RE: 1000 Avonoak Terrace
Design Review PDR 1608723

City of Glendale
Community Development Department
Design Review Staff Report – Single Family

Meeting/Decision Date: July 11, 2016	**Address:** 1000 Avonoak Terrace
Review Authority: ☐DRB ☒ADR ☐HPC ☐CC	**APN:** 5665-007-003
Case Number: PDR1608723	**Applicant:** Aram Alajajian
Prepared By: Kathy Duarte	**Owner:** Leslie Nishanian

1 PROPOSED SECOND FLOOR PLAN

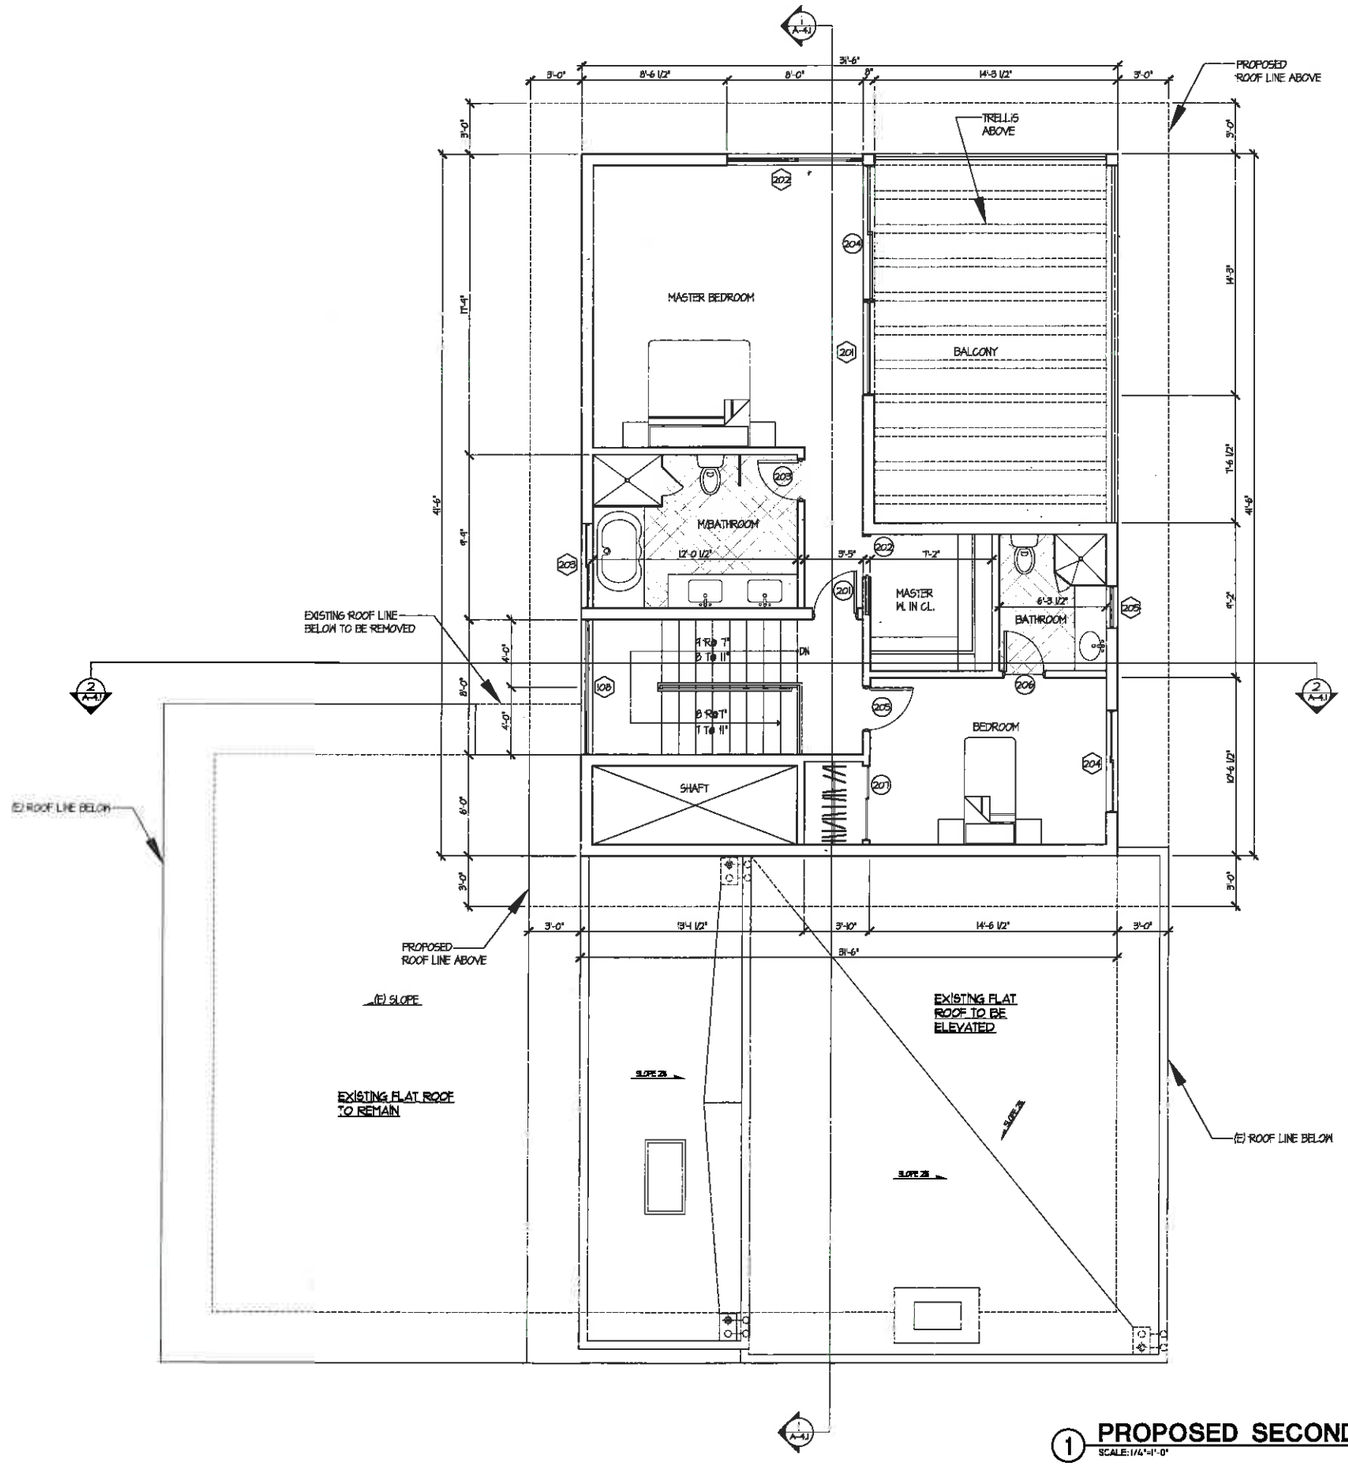
Staff recommends a condition to reduce the second floor ceiling height to be 8 feet.

Staff also recommends a condition to remove the boxed-out fascia framing at the rear roof deck. A less bulky trellis structure is acceptable.

Staff is recommending that the second floor deck be reoriented or a permanet barrier established to avoid views into the neighbors bedroom windows.

4. Reduce the height of the proposed second floor ceiling to be 8-feet maximum to reduce the overall mass of the addition.
5. Minimize the glass area in the new stair well to avoid direct view towards the neighbors at the second floor or use obscured glass. Consider orienting glass towards the front elevation.

11. Provide a vertical window section/detail.
12. Reorient or redesign the proposed second floor deck to avoid direct views into the adjacent properties bedroom windows.
13. Retaining wall/planters at property lines should use a decorative material, such as split face block, on the neighbor's side.
14. Grading at rear yard retaining walls appears steeper than drawn. Provide sections to verify location of the property line, grading and height of retaining walls.
15. Landscaping on the backyard slopes is to be replanted with drought tolerant and MWELO compliant landscaping to match or complement the new proposed landscaping and be included on the landscaping plans.

1 PROPOSED NORTH ELEVATION

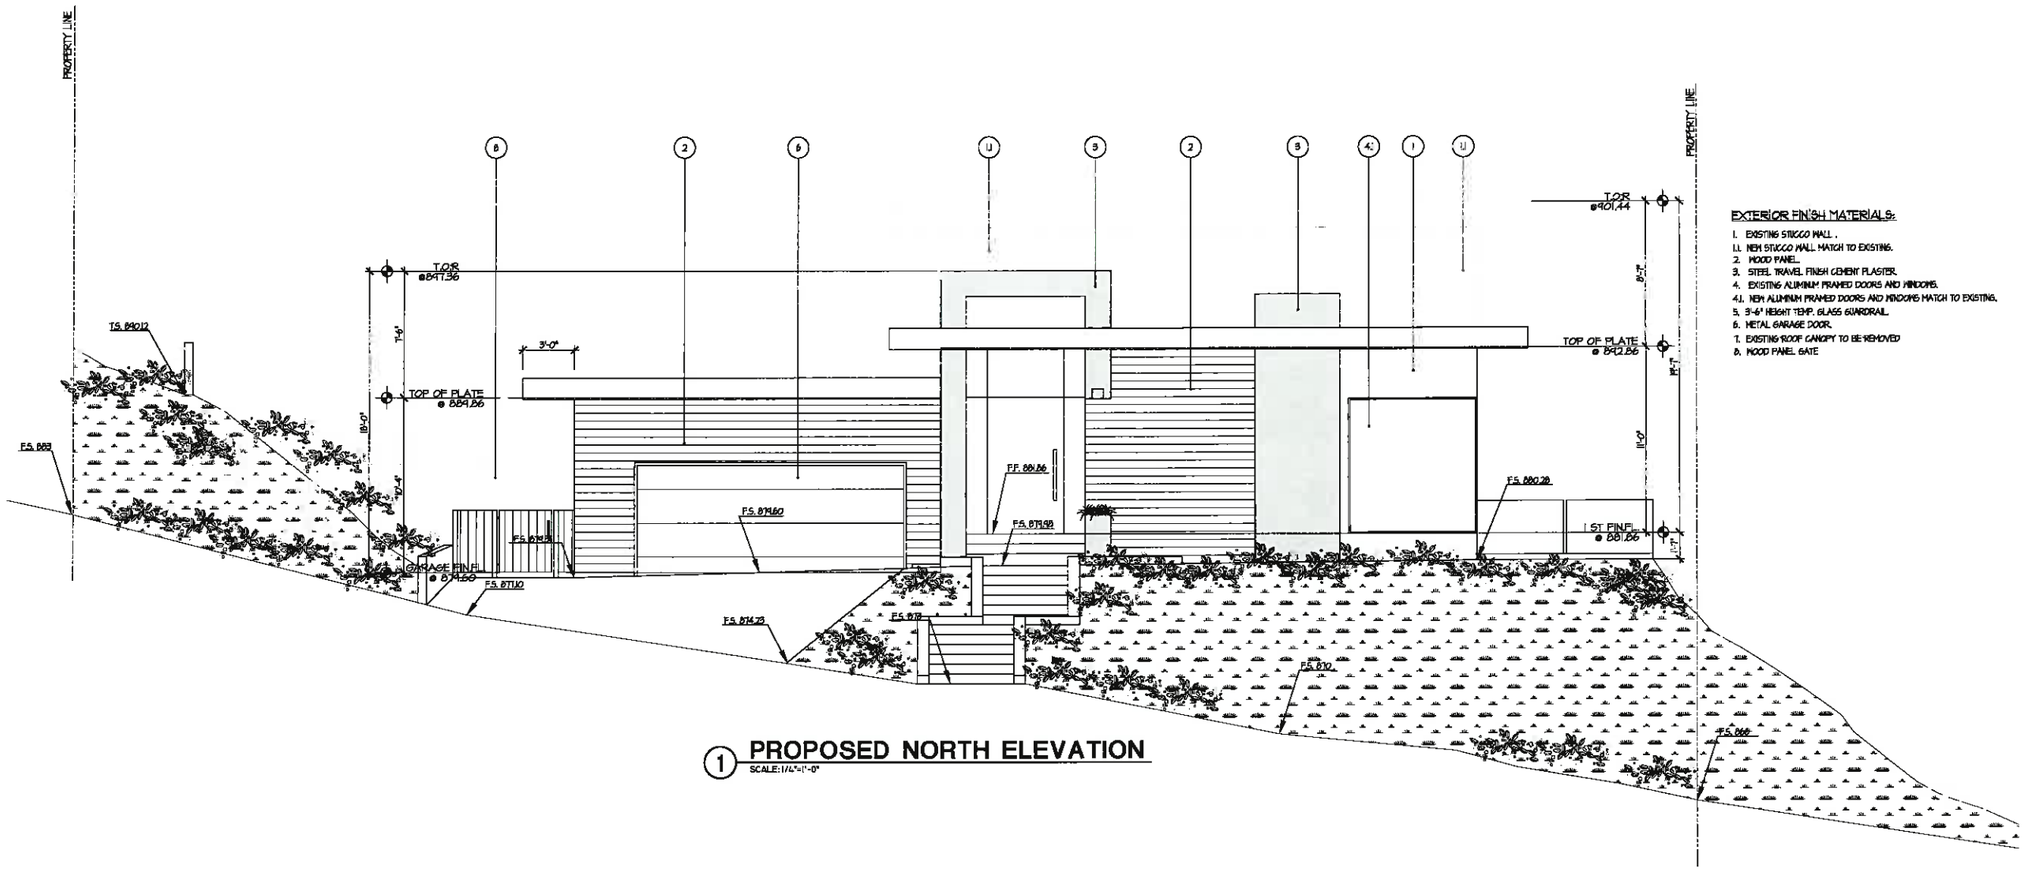
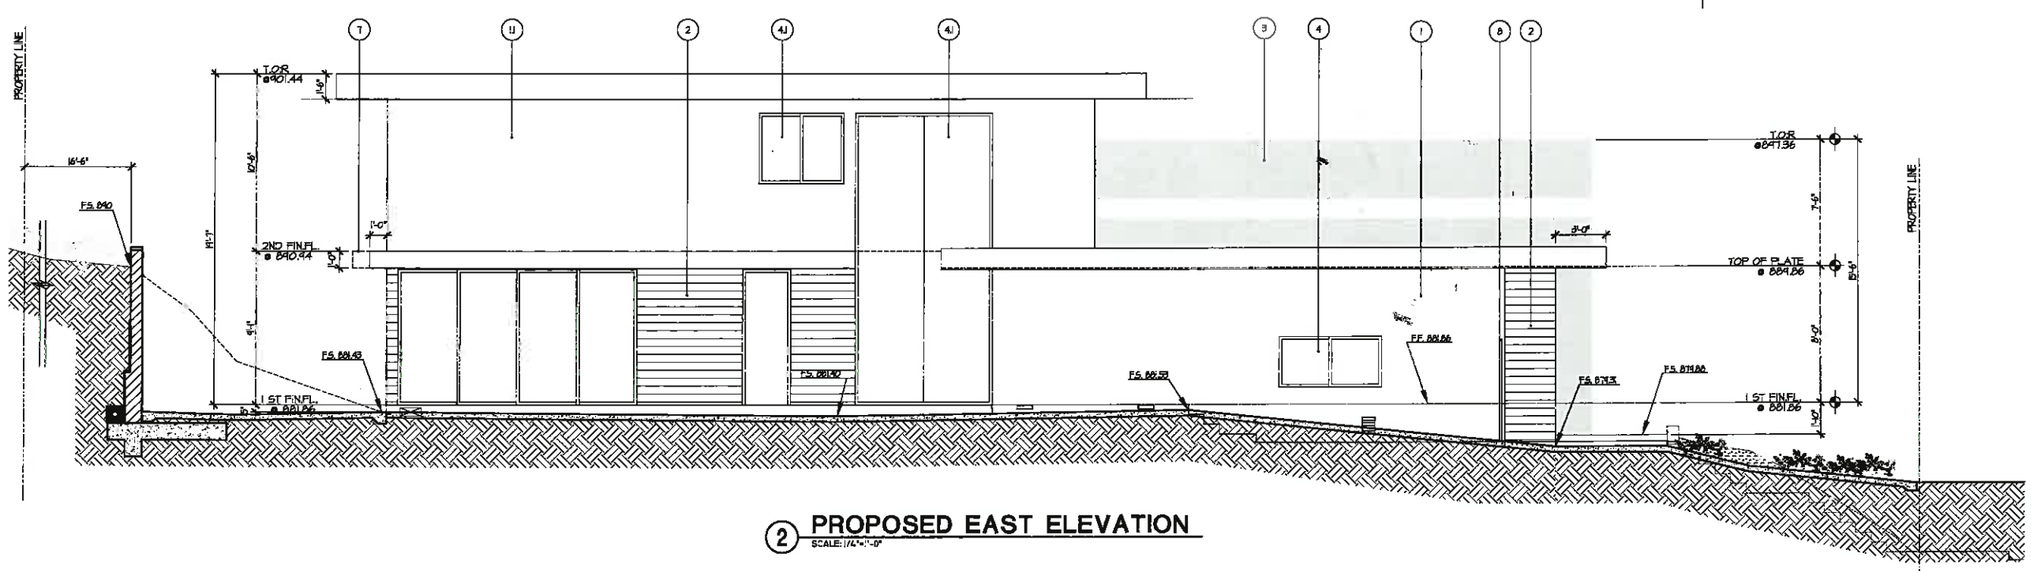
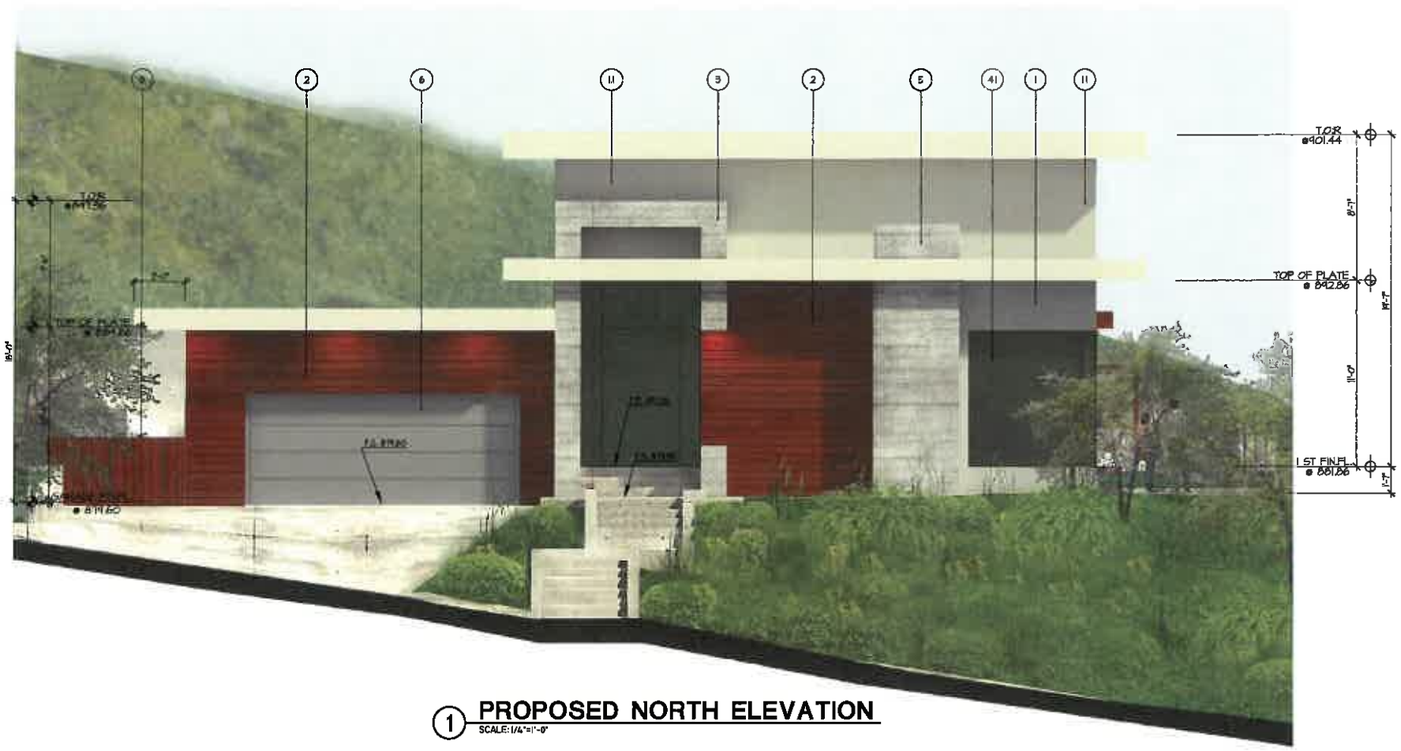
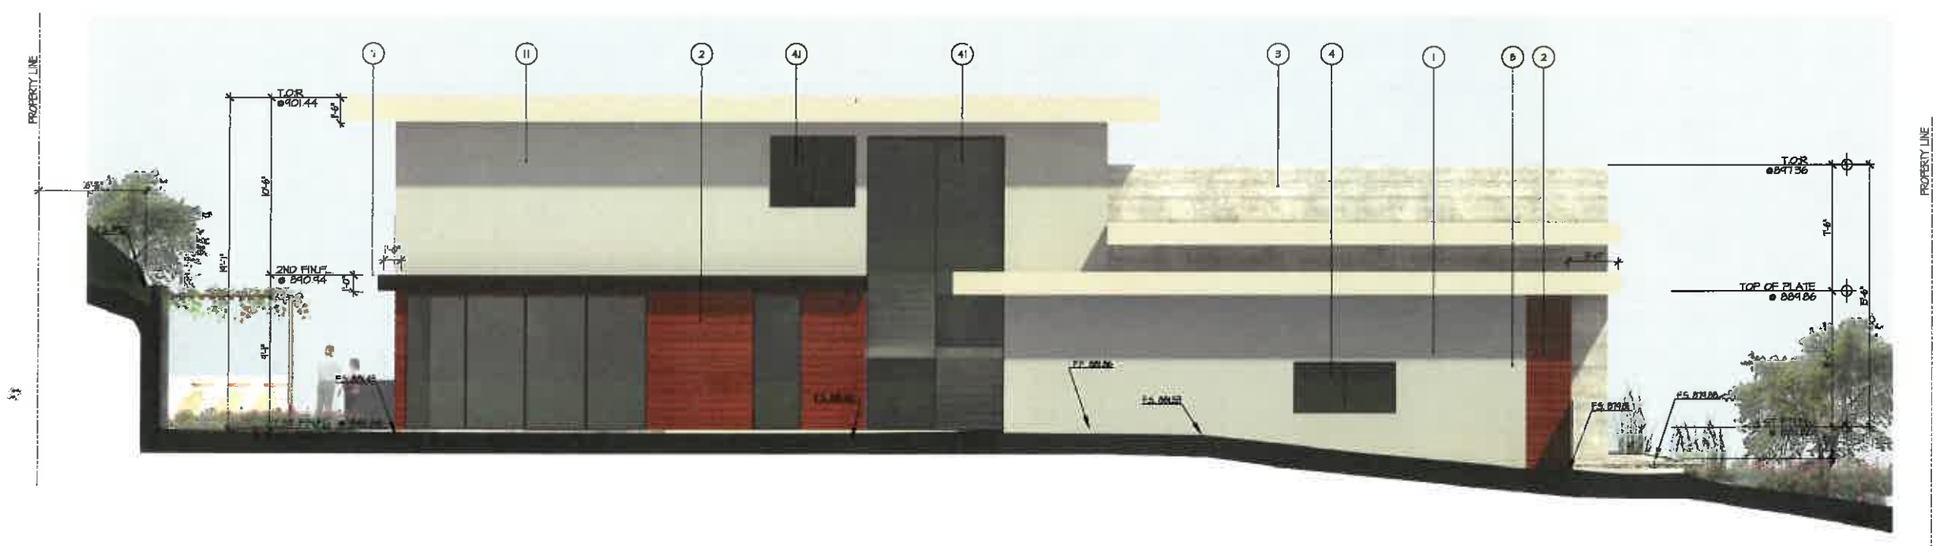
Staff recommends at the front elevation: that the proposed increase in height at the reconfigured open living room/dining room be limited to a 10-foot ceiling height; that the proposed height increase at the front entry and stairs be reduced to a 10-foot ceiling height (to align with the living/dining room); that the existing height of the fascia be verified and maintained throughout the project; that the area designated vertical shaft be eliminated and the wall and roof notched to break up the mass.

Staff also recommends a condition that fenestration be added at the second story front addition to minimize the blank stucco wall.

- Staff recommends elimination of the vertical shaft at the front façade that adds unnessary mass to the addition and recommends the addtion of fenestration to add more detail to the blank stucco walls.

The proposed design raises the ceilng height at the entry to appoximately 14 feet. Staff is recommending a condition that the ceiling height not exceed 10 feet to avoid monumental proportions and ensure better integration into the overall frontage of the structure.

2. Reduce the ceiling height of the reconfigured open living /dining rooms from the proposed 11-foot height to a 1o-foot maximum ceiling height. Adjust the height of the chimney to be proportional.

3. Reduce the ceiling height at the front entry stairs/hall to match the conditioned 10-foot ceiling height of the living /dining room to establish a consistent intermediate roof line at the front façade and to avoid monumental proportions.

6. Eliminate the area designated as a vertical shaft (adjacent to the front elevation) to reduce the bulk of the building. Notch the roof and wall to minimize the mass.

7. Add fenestration to the front façade at the second floor to minimize the expansive, blank stucco walls.
8. Eliminate the boxed –out fascia outlining the second floor deck to reduce the apparent mass of the new second floor addition.

1 **SECTION 1-1**
SCALE: 1/8"=1'-0"

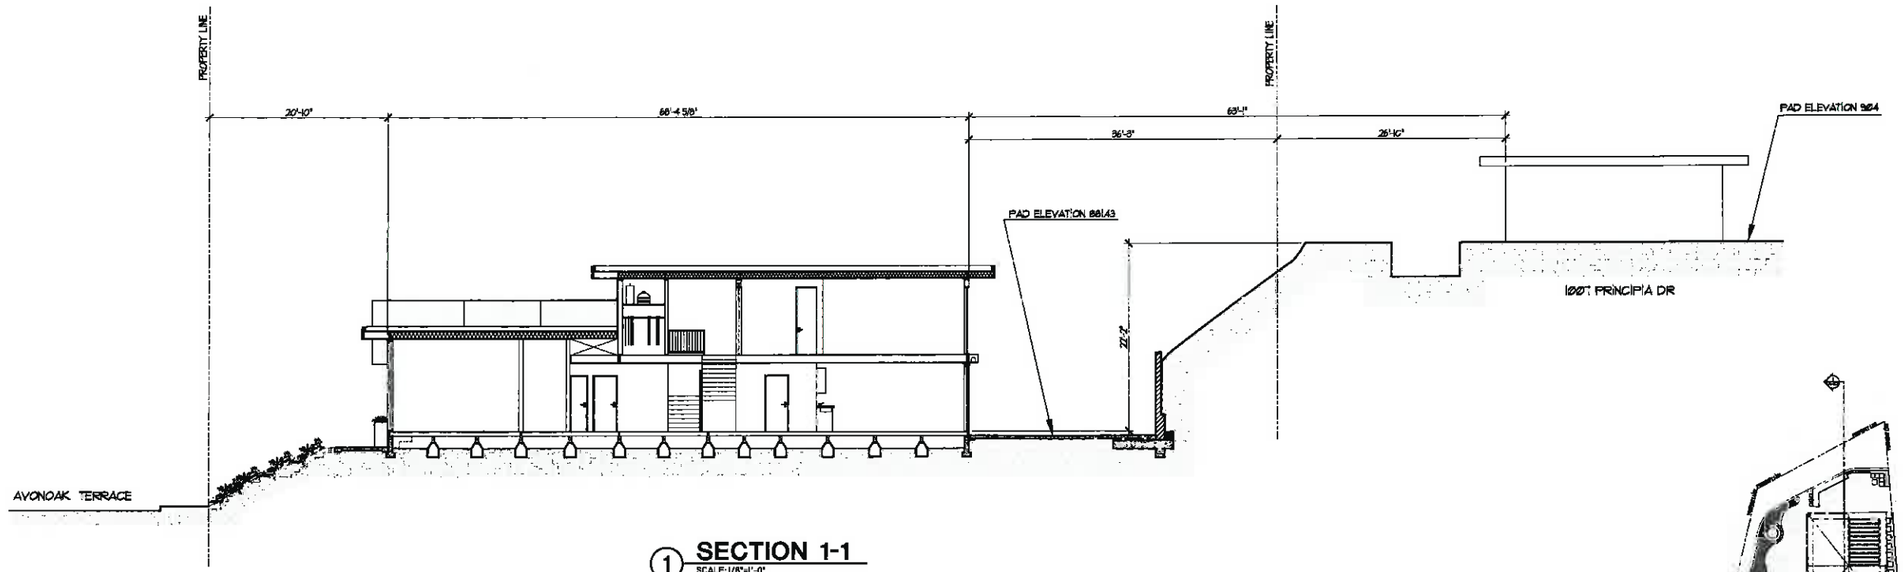
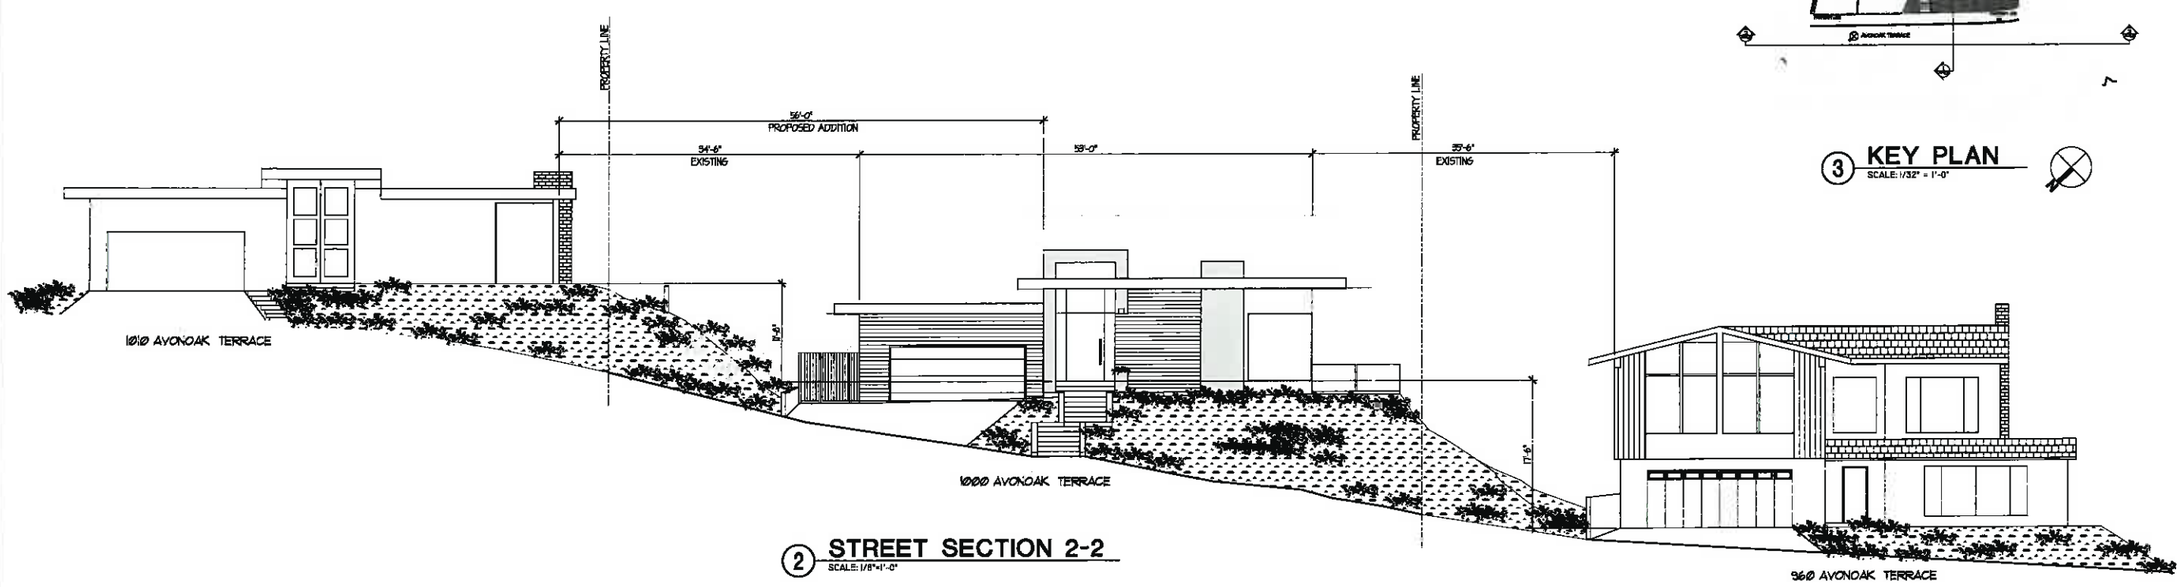
Site sections through the rear yard where it is being expanded do not appear to accuately show the steepness of the existing topography. Staff is recommending a condition to verify the property line, steepness of slope and retaining wall height.
